SUBJECT: Peach Bottom Atomic Power Station, Units 2 and 3
Station Blackout Response to NRC Questions Concerning
the Use of the Conowingo Hydroelectric Power Station
as the Alternate AC Power Source

Peach Bottom Atomic Power Station, Units 2 and 3
Response to Questions Regarding Use of
Conowingo Line in Station Blackout Analysis

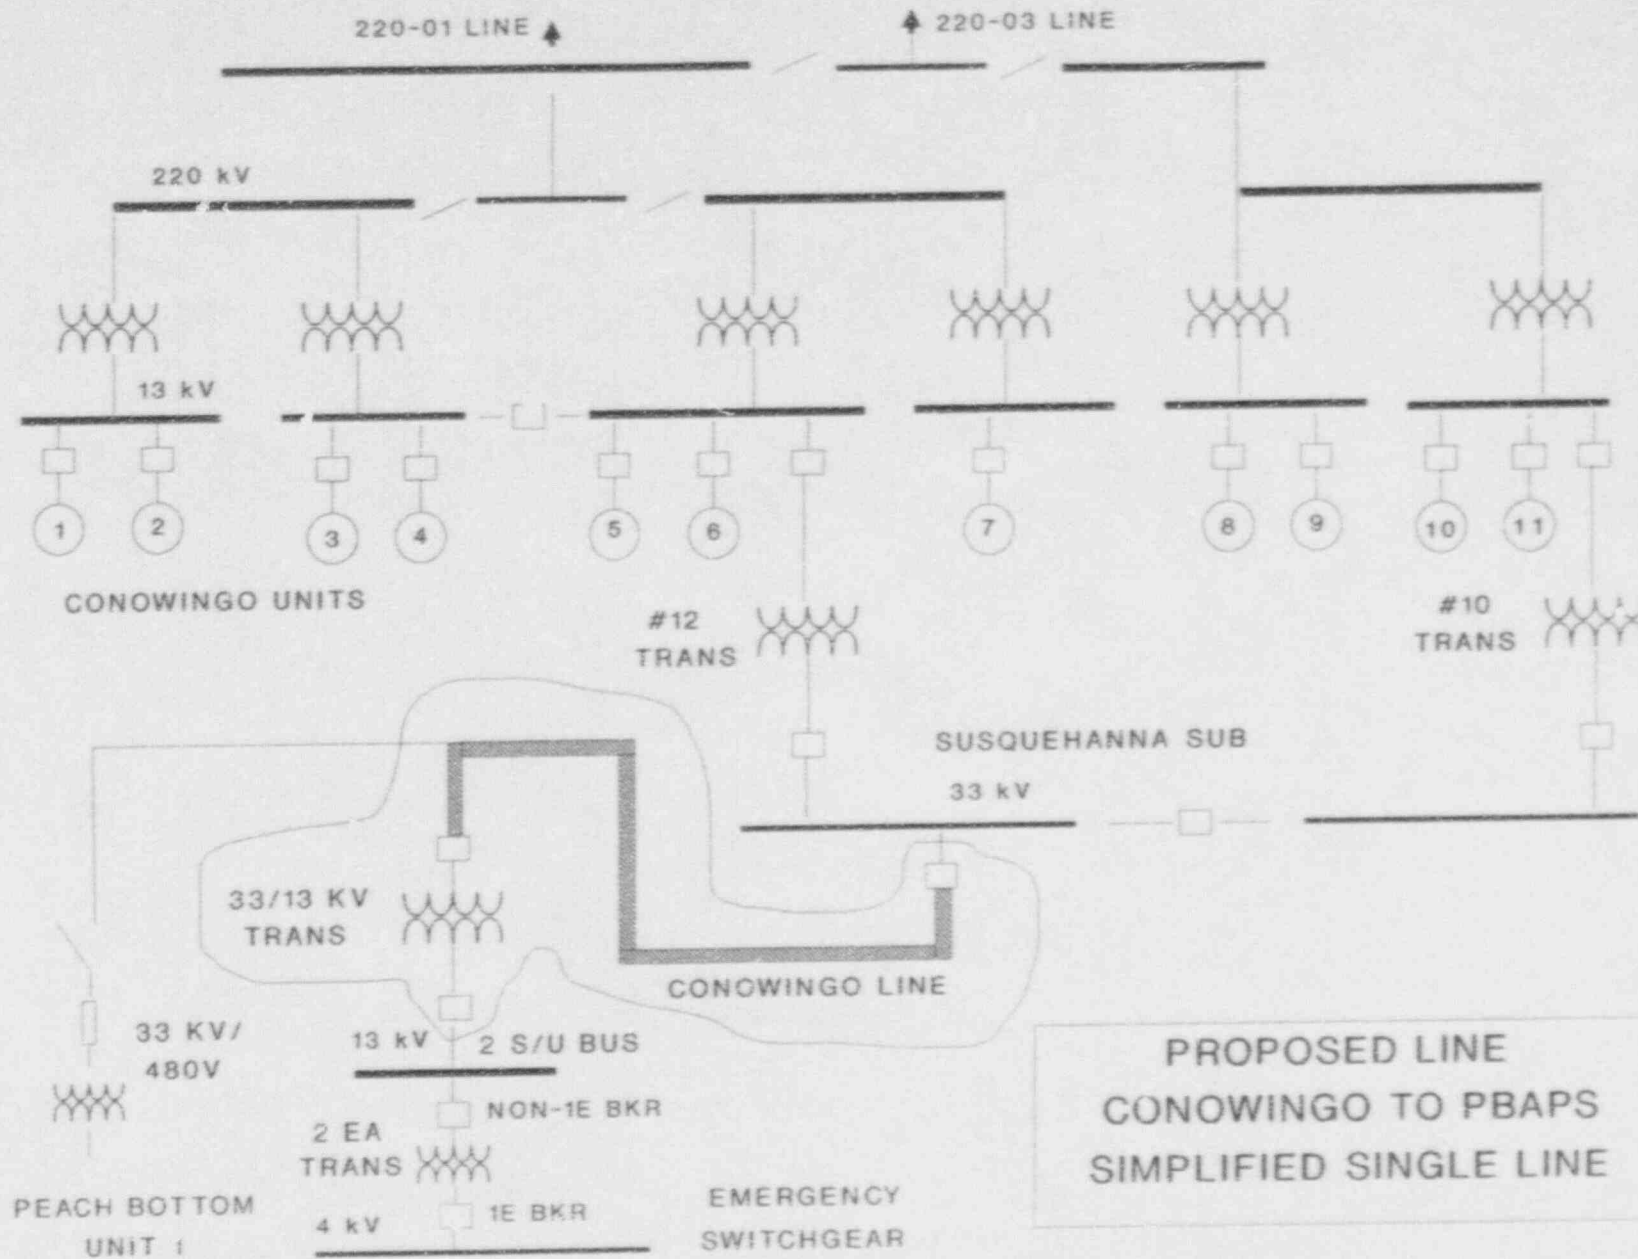
1. Provide a complete description of the proposed circuit from the Conowingo Station to the Peach Bottom safety buses. One-line diagrams showing the hydro units, buses, transformers, breakers, protected transmission line, associated voltage levels and capacities, and extent of protection against weather related events would be acceptable.

The proposed line from Conowingo Hydroelectric Power Station (Conowingo) to Peach Bottom Atomic Power Station (PBAPS) is designed to support the necessary loads (i.e., safe shutdown of both units from full power operation) during a Station Blackout (SBO). A SBO is defined as loss of the preferred offsite power supplies and loss of the four station emergency diesel generators (EDGs). The proposed line will function as the alternate AC (AAC) power supply as defined in Regulatory Guide (RG) 1.155, "Station Blackout" and NUMARC 87-00, "Guidelines and Technical Bases for NUMARC Initiatives Addressing Station Blackout at Light Water Reactors." The line is designed to support a continuous load of 15MVA. The line is located to take advantage of the highly reliable and available Conowingo generating units. Attachment 1 provides a simplified single line of the proposed design.

The proposed 33kV line will initiate at the 33kV Susquehanna Substation located at Conowingo, and will terminate at a 33/13kV-15MVA transformer to be located at PBAPS. The transformer load side (13kV) will be connected to the PBAPS No. 2 13kV startup bus which provides power to the 4kV emergency buses via the 2EA transformer (13/4kV).

- B.6 The Conowingo line will be connected to the PBAPS No. 2 13kV startup buses which are non-safety related; therefore, isolation will be provided by the existing Class 1E safeguards 4kV bus breakers and the non-class 1E 13kV startup feeder breaker to the Unit 2 emergency auxiliary transformer. See Attachment 1 for a simplified single line diagram of this configuration.
